U Control Circuit Board

Date: July 30, 2015
Models or Product Affected: Cruisair & Marine Air Systems
Recipients: Dealers, Master Dealers, Distributors, OEMs, Manufacturer's Reps

New U-Control Circuit Board For Cruisair and Marine Air Systems

U Control Circuit Board, Rev G

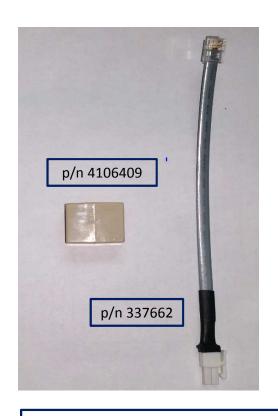
Move the Bimini jumpers away from cap to make it easier to access

Move the transformer and cap away from the edge of the board to better protect the cap.

Added cuttable jumpers to allow pump, rv valve, or compressor snubbers to be disabled Changed display & temp jacks to through hole jacks for better durability

Adaptors for U Control Circuit Board

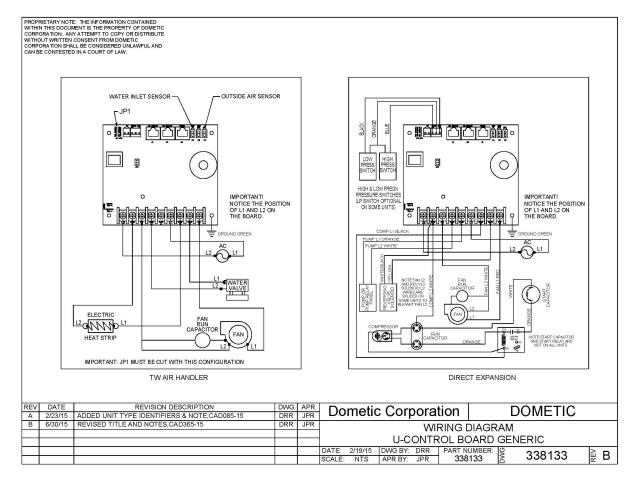
Adapters are necessary for retrofits or optional sensors.

New units will arrived with new sensors

p/n 337788 DC adaptor for DC operation will no longer be needed with Rev E U-Boards

Kit Number 222103190 ADAPT SENSOR U-CNTRL WTR/OAS
